## AIRWORTHINESS DIRECTIVE

Issue 3

BLANIK L13  
BLANIK L13 A1  
BLANIK with power pack modification.

Aerotow release hook modification.

MODIFICATION

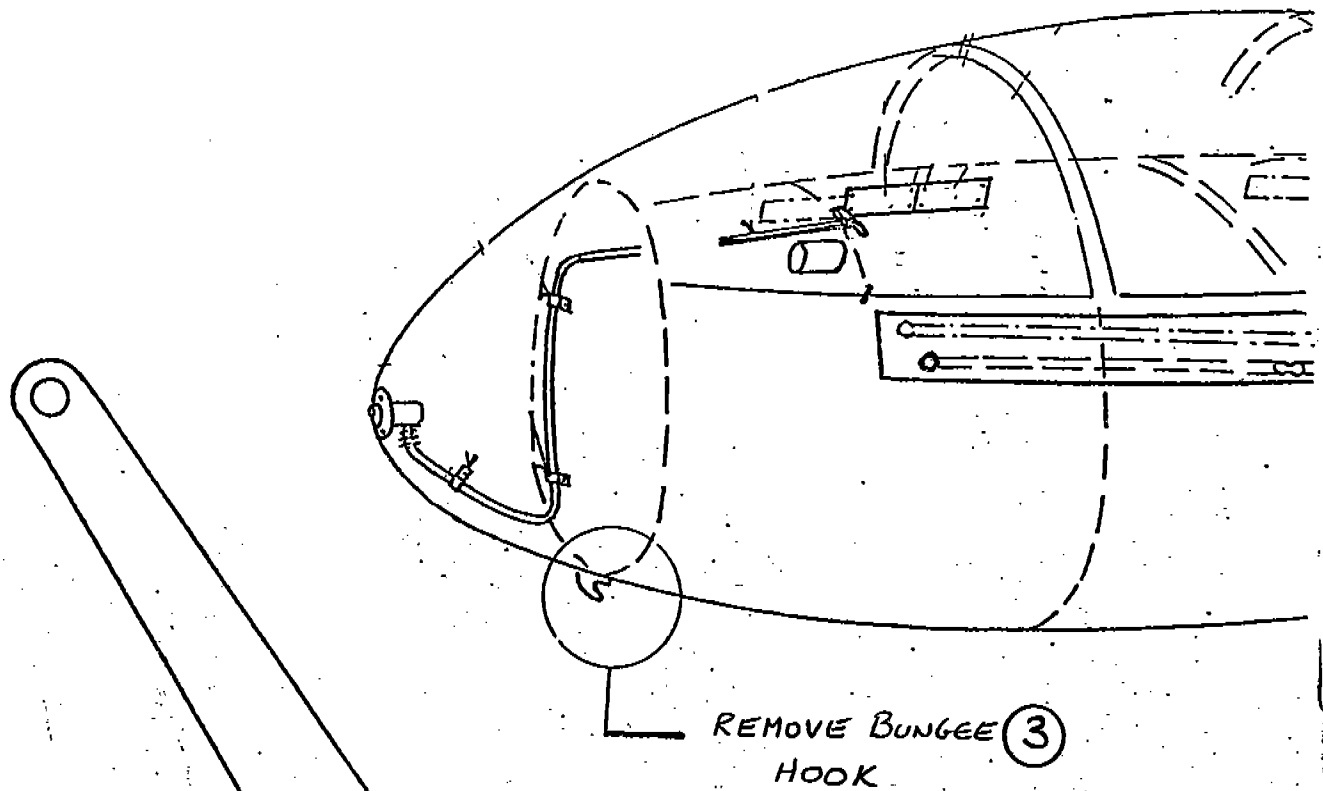
- (1) The toggle link stop pin is to be removed and a 11 mm steel bush is to be fitted over the stop pin so that the toggle link over centre travel will be limited to 2 mm. It will be also necessary to re-work the toggle return spring to fit over the bush. (Hole through bush to suit size of existing bolt).
- (2) To overcome the pinching action on the tow rope ring the tip of the hook must be modified as shown on the enlarged detail of the attached drawing (Sheet 3). As the hook is hardened steel the tip profile must be modified by grinding to the shape shown.
- (3) Hacksaw off the bungee hook, such that there is no possibility of a towrope or ring catching and causing a "hang up" (Sheet 4).

Fit 11 mm. O.D.  
STEEL BUSH OVER PIN  
TO LIMIT OVER CENTRE  
TRAVEL TO 2 mm.  
BUSH LENGTH TO BE  
NEAT FIT BETWEEN  
HOUSING SIDE PLATES.  
REWORK SPRING END  
TO FIT.

OVER CENTRE TRAVEL WAS 4mm APPROX,  
NOW REDUCED TO LESS THAN 2mm.

GRIND OFF SHADED  
SECTION OF HOOK  
AND ROUND OFF  
THE END OF  
THE HOOK

MINIMUM 45°

THIS LINE PARALLEL TO BOTTOM OF SIDE PLATES

SCHEMATIC TEST  
PROCEDURE

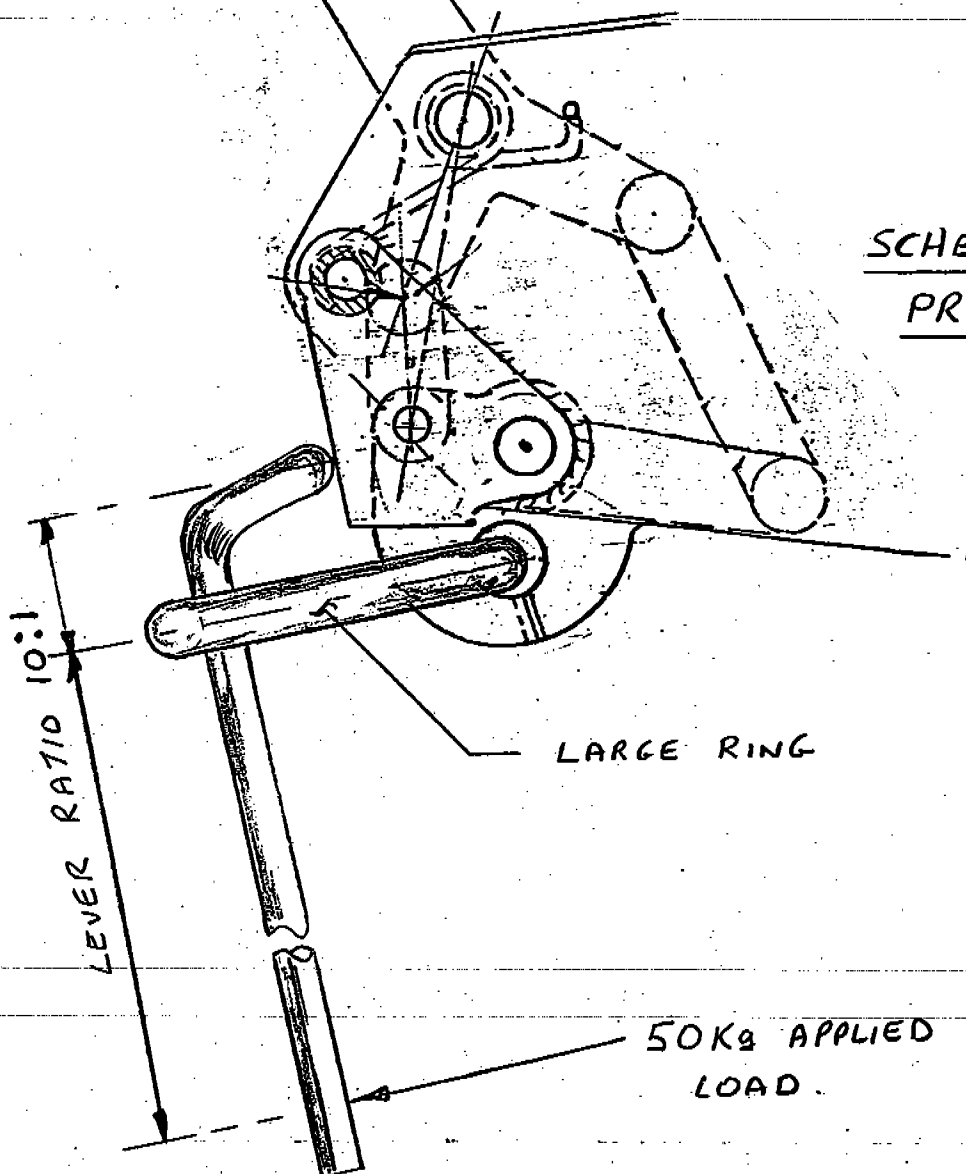
## SHEET 3 ILLUSTRATES A TEST METHOD:

- (1) Remove the nose cone
- (2) Using a lever against the release housing, through the ring, apply a load to the ring, pulling on the beak in a forward direction.

- (3) The final load developed at the beak should be equal to the weak link strength - 1100 lbs (500 kg) (Use a 10 : 1 lever and a 50kg spring balance).

- (4) Function the front cockpit release handle and check for smooth release with no tendency for the beak to "nip" and hold the ring.
- (5) Measure by spring balance the front cockpit pilot effort to release the ring loaded to 1100 lbs.

# BLANIK RELEASE TESTER

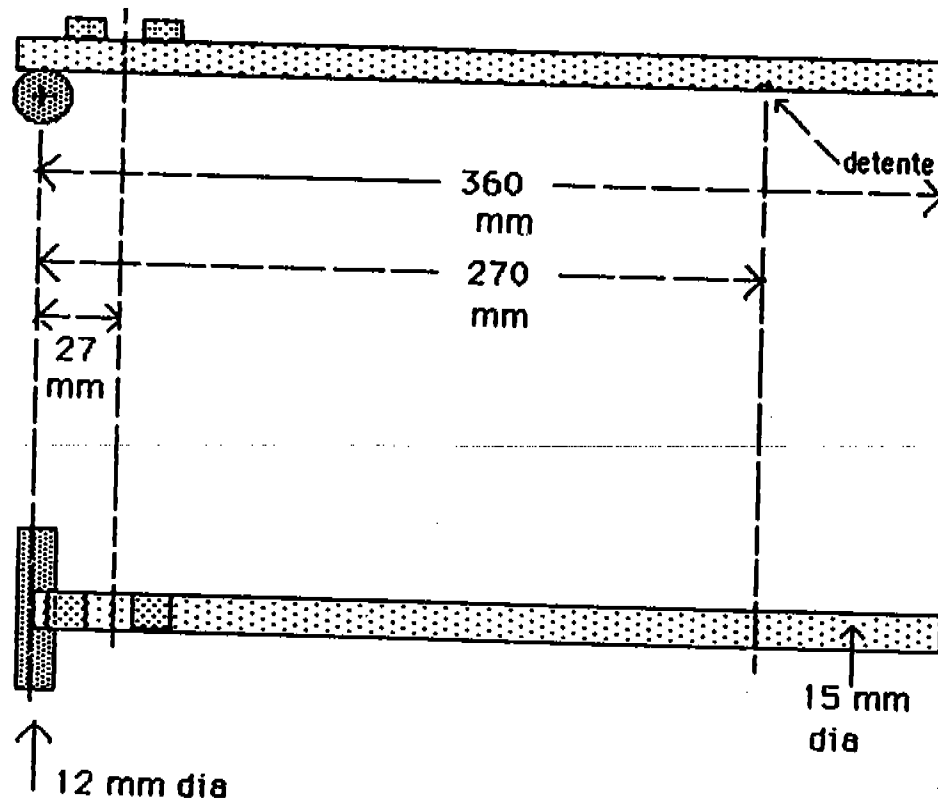
design - Keith Hayden, Orons Club

mild steel throughout - welded construction
